**SAFETY INTEGRITY ASSESSMENT OF EASA PROPOSALS  
for  
MANDATORY EMERGENCY LOCATION TRANSMITTERS  
&  
FLOATATION EQUIPMENT**

**ROBINSON R22 & R44 HELICOPTERS**

Technis Report No T470

1.1.1 To respond to EASA consultation document NPA 2009-02b pages 41-46 & 197-205 (ref 5.6).

**FIGURE 3.1a- FAULT TREE - INVOLVING NO ELT**

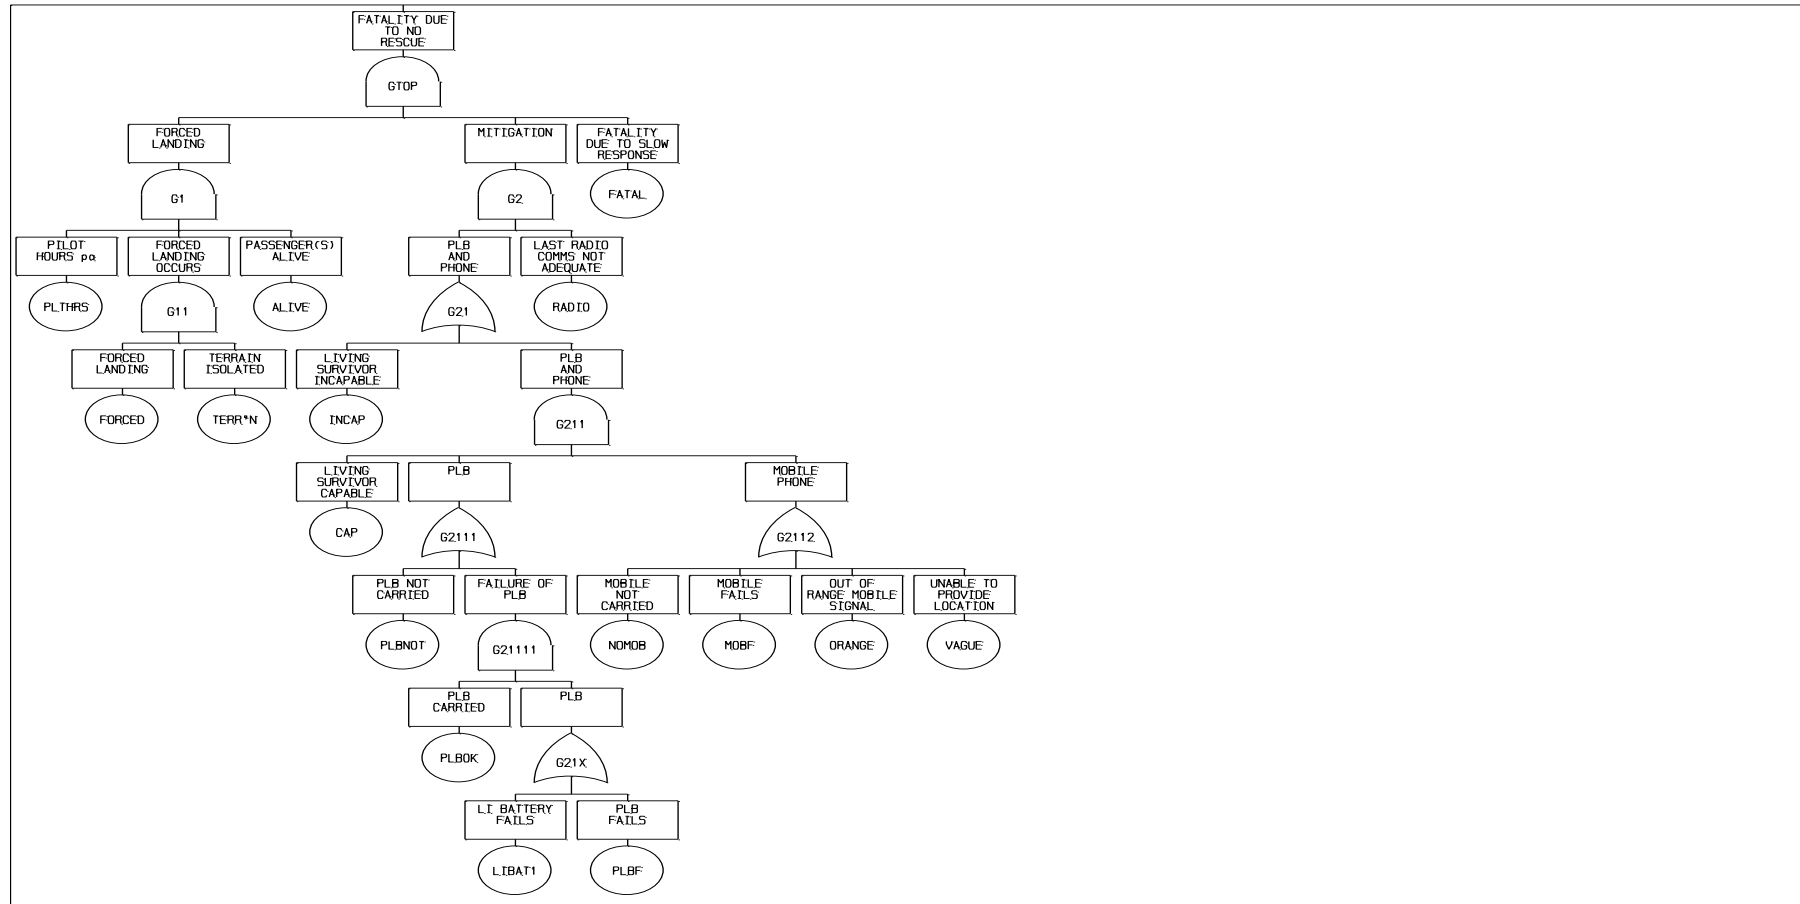
The fault tree (Figure 3.1a) was constructed to model the scenario without the benefit of an ELT. It was analysed using the TECHNIS fault tree package TTREE (Ref 5.5). The details are shown in Appendix 1. The frequency of the top event is **8.6 10<sup>-5</sup> pa** which meets the target.

The fitting of emergency location transmitters shall be optional.

**FIGURE 3.1b- FAULT TREE - INVOLVING AN ELT**

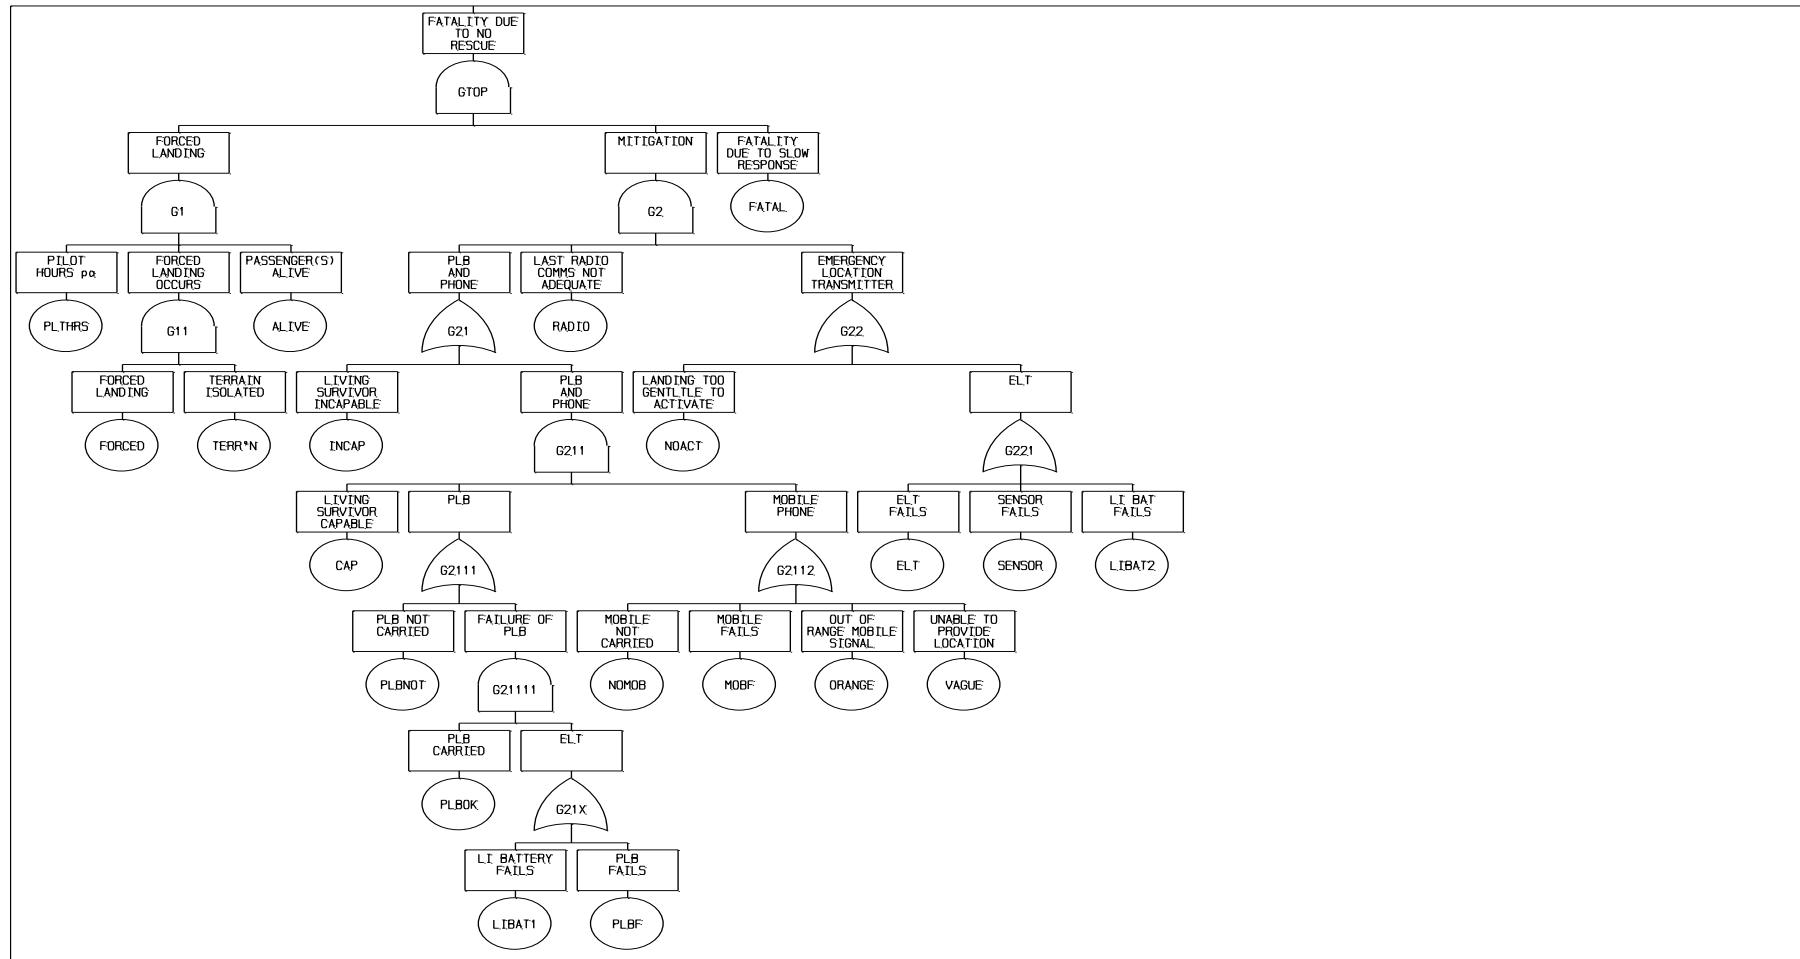
(Figure 3.1b) shows the modified fault tree which credits the mitigation offered by the ELT. The details are shown in Appendix 1. The frequency of the top event is **1.1 10<sup>-5</sup> pa** which meets the target.

$$£5,000 / (8.6 \times 10^{-5} - 1.1 \times 10^{-5}) \times 1 \times 10 = \text{£7 Million pounds.}$$

Since this exceeds the criterion mooted in section 1.4, ALARP is claimed to be satisfied without the additional risk reduction.

**FIGURE 3.2a- FAULT TREE – INVOLVING NO FLOATATION EQUIPMENT**

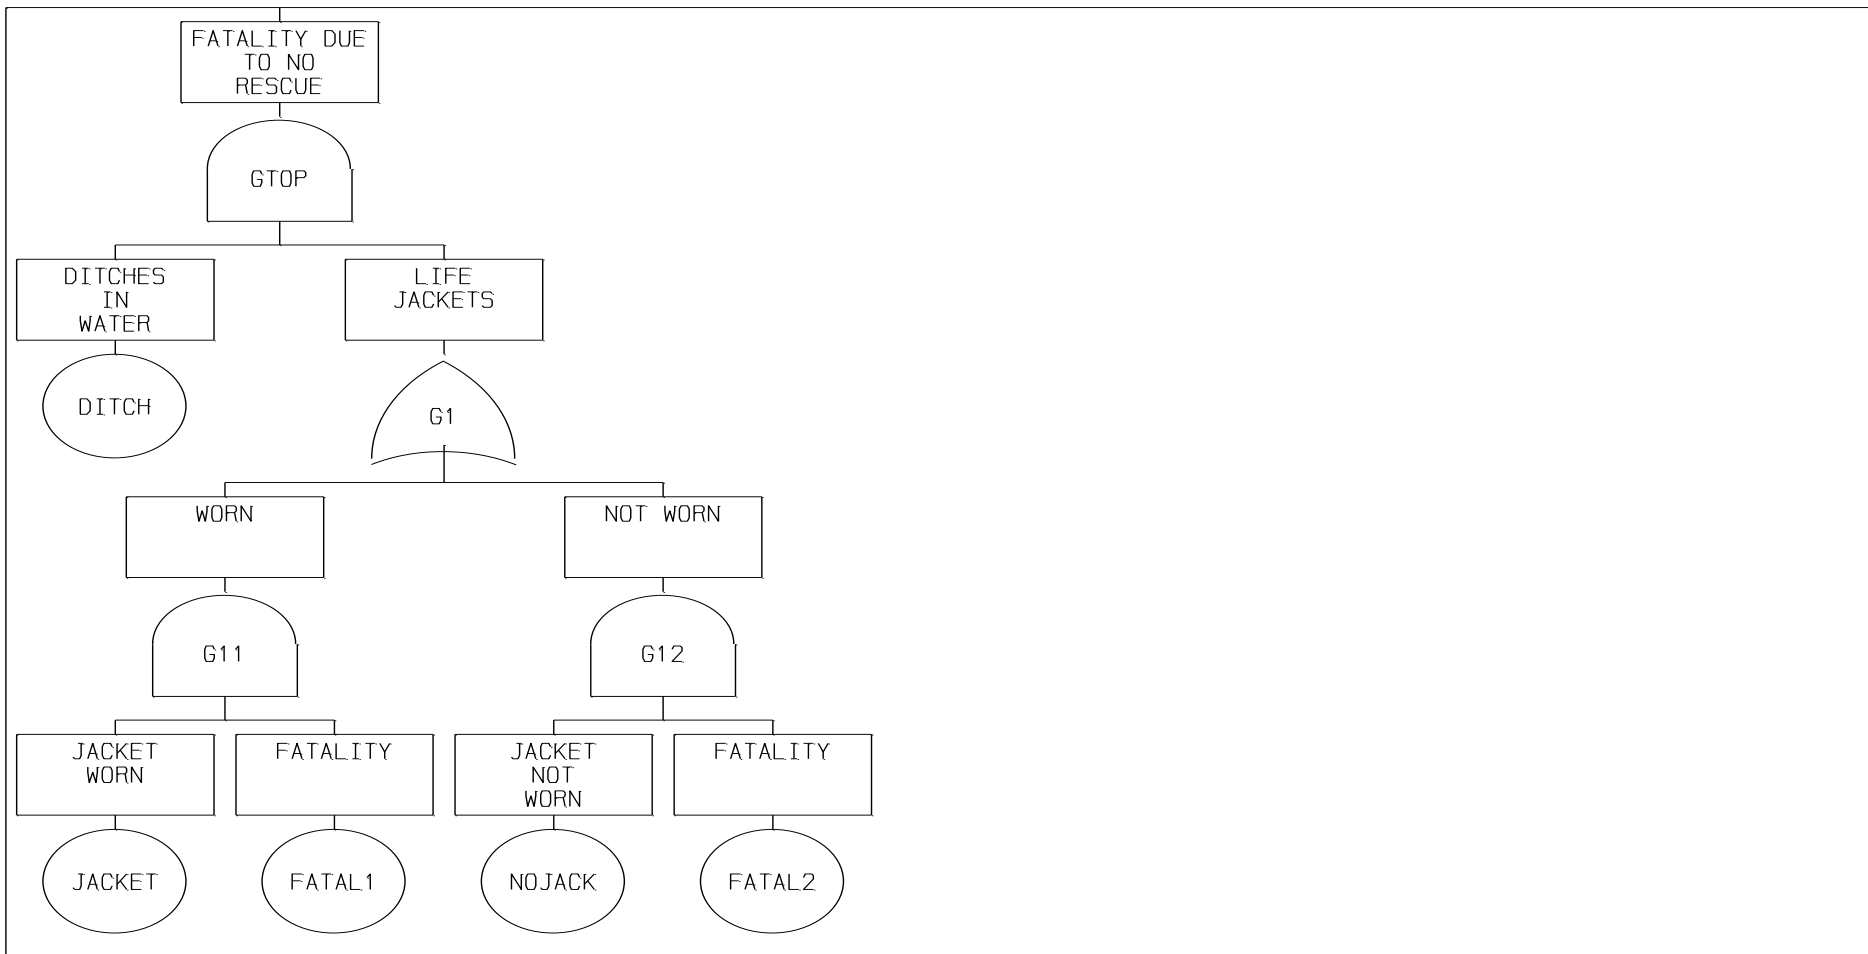
The fault tree (Figure 3.2a) was constructed to model the scenario without the benefit of floatation equipment. It was analysed using the TECHNIS fault tree package TTREE (Ref 5.5). The details are shown in Appendix 1. The frequency of the top event is  $7.2 \times 10^{-5}$  pa which meets the target.

The fitting of floatation equipment shall be optional.

**FIGURE 3.2b- FAULT TREE – INVOLVING FLOATATION EQUIPMENT**

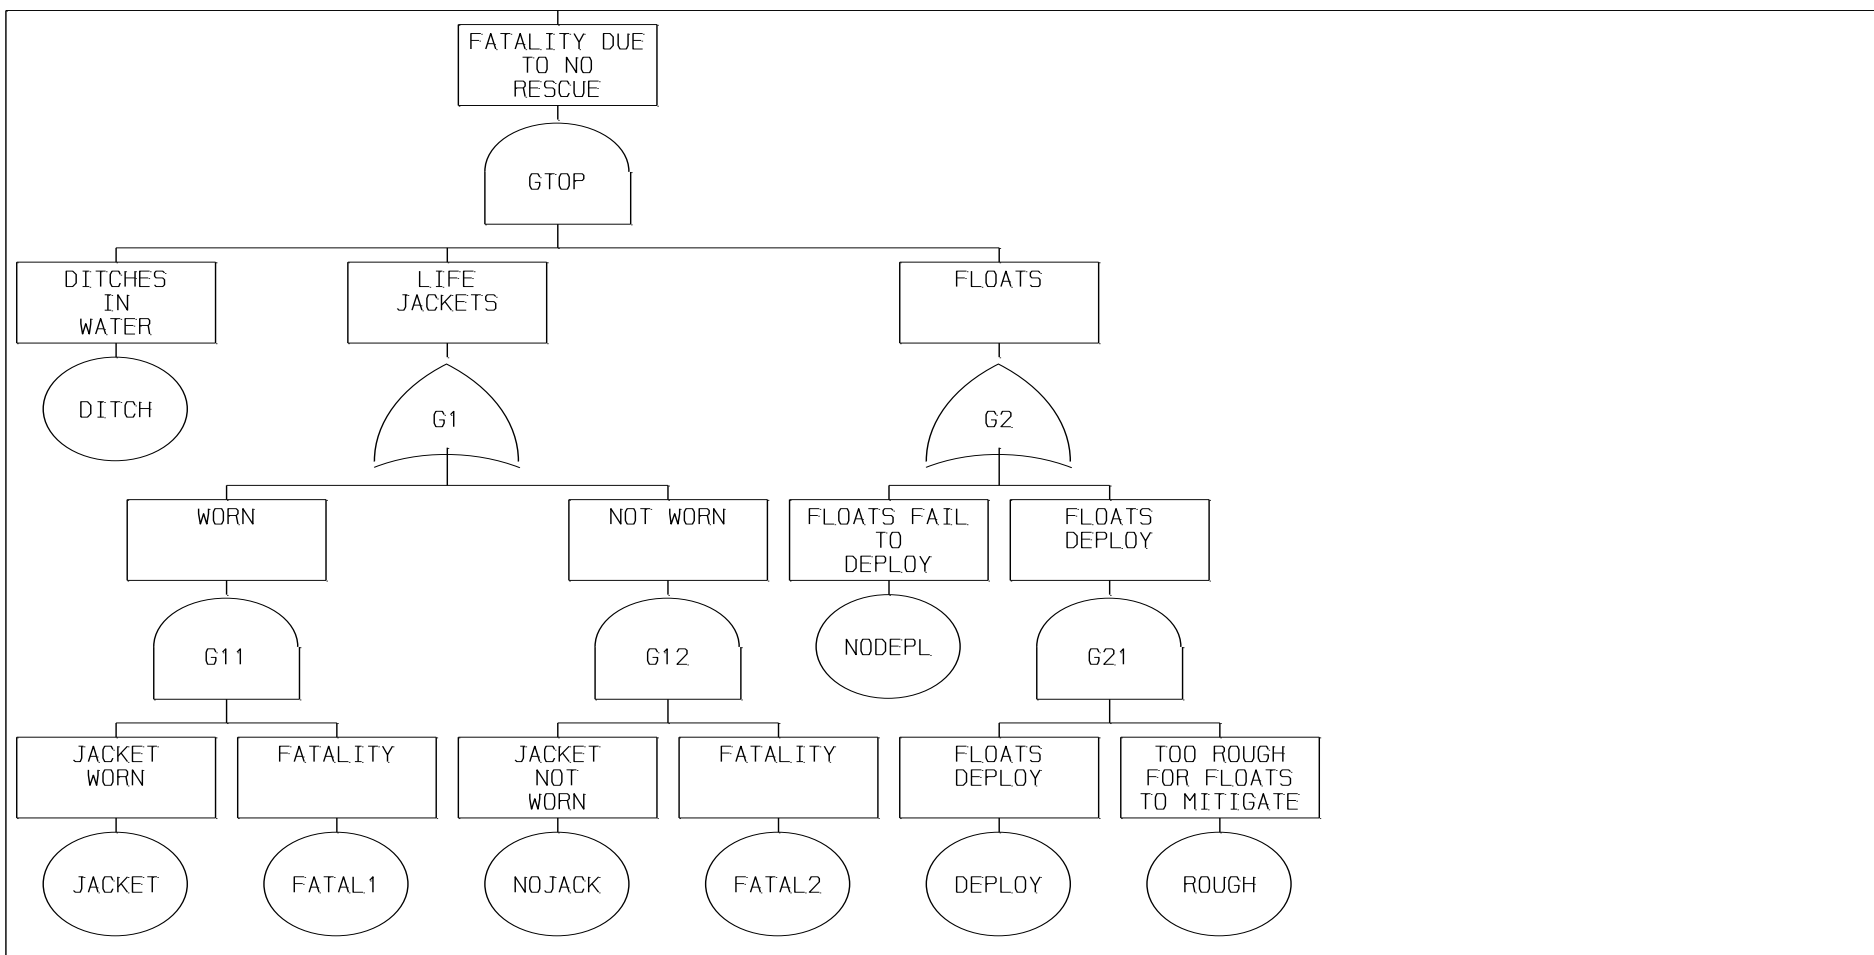
(Figure 3.2b) shows the modified fault tree which credits the mitigation offered by floatation equipment. The details are shown in Appendix 1. The frequency of the top event is  $1.5 \times 10^{-5}$  pa which also meets the target.

$$£17,000 / (7.2 \times 10^{-5} - 1.5 \times 10^{-5}) \times 2 \times 10 = \text{£15 Million pounds.}$$

Since this exceeds the criterion mooted in section 1.4, ALARP is claimed to be satisfied without the additional risk reduction.
